SUBJECT: INTAKE STRUCTURE REPAIR, SAN ONOFRE NUCLEAR GENERATING STATION,
UNIT NO. 1 (TAC NO. 74168)

RAI ON REPAIR OF DEGRADATION
OF INTAKE STRUCTURE AT SONGS-1

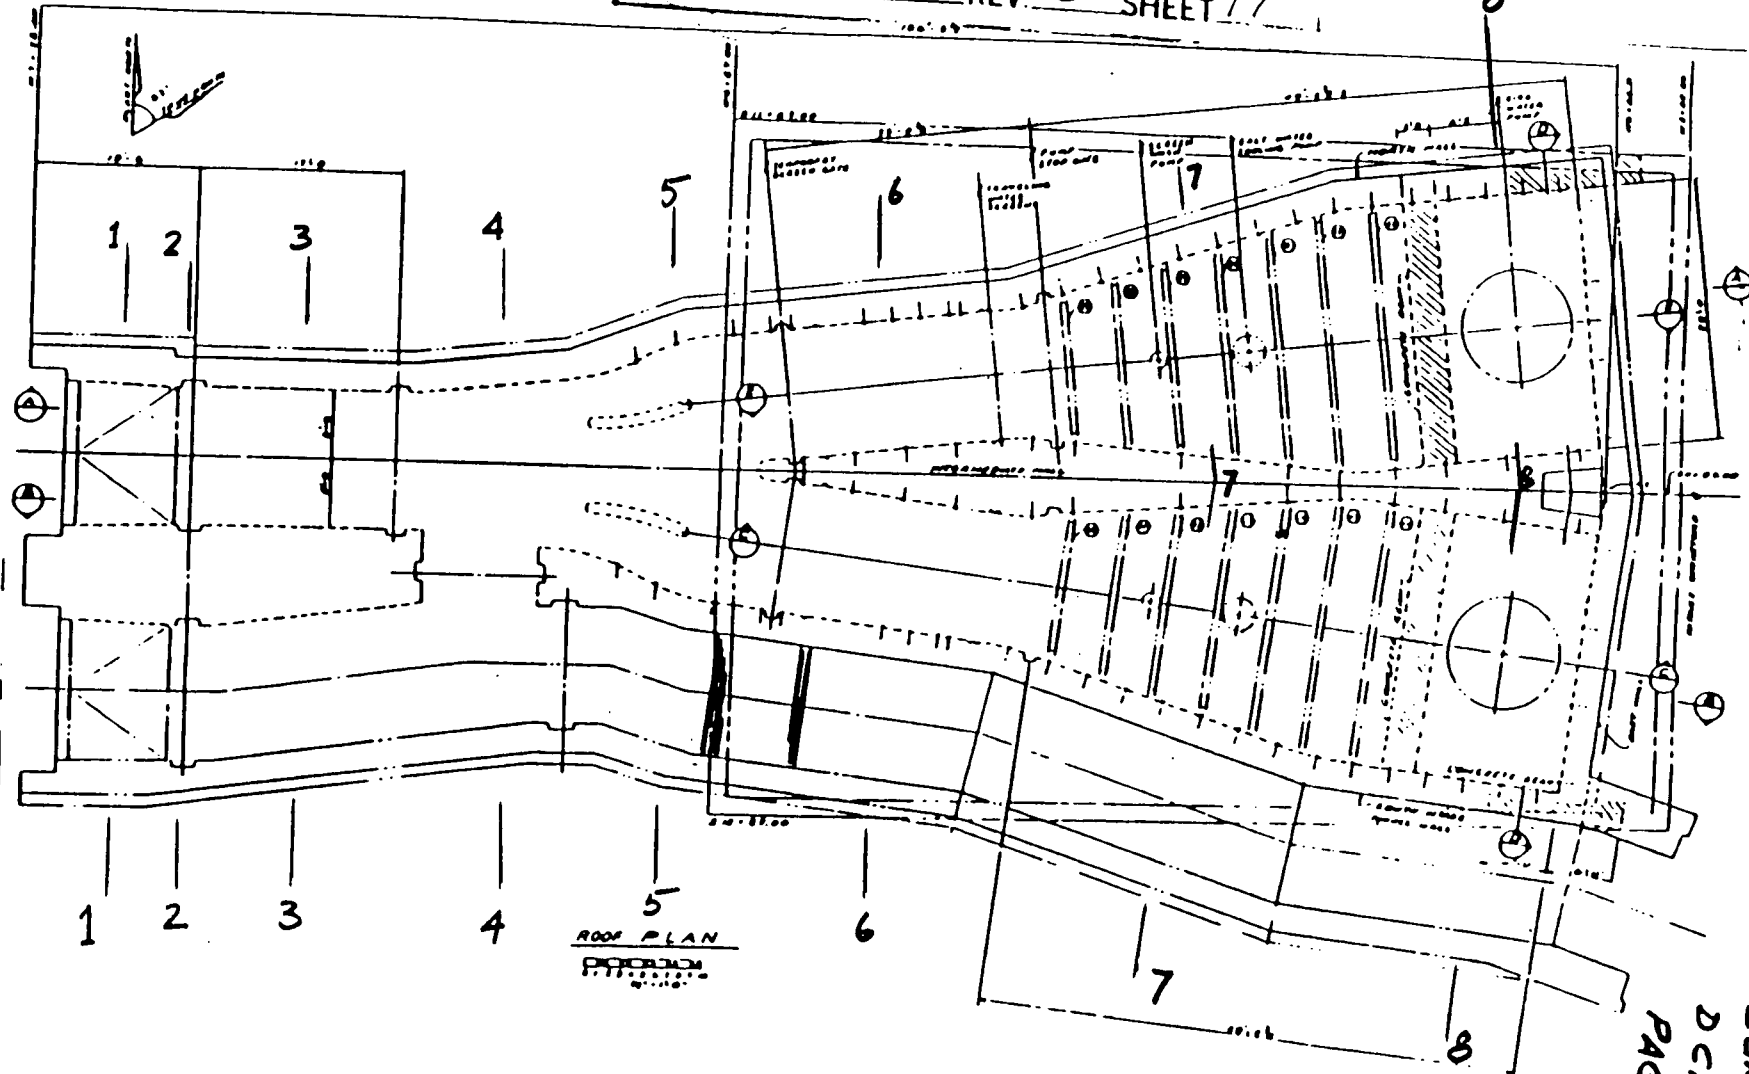
5. Provide cross-sectional details of sections (1-1 to 8-8) shown on the attached sketch (Attachment 1) indicating grade levels, water levels (normal and fluctuations), wall and slab thicknesses, beam dimensions, reinforcing provided, major embedments in concrete, and pump support locations. Also, indicate ground water fluctuations in the backfill, and foundation strata below the base slabs and around the tunnel.
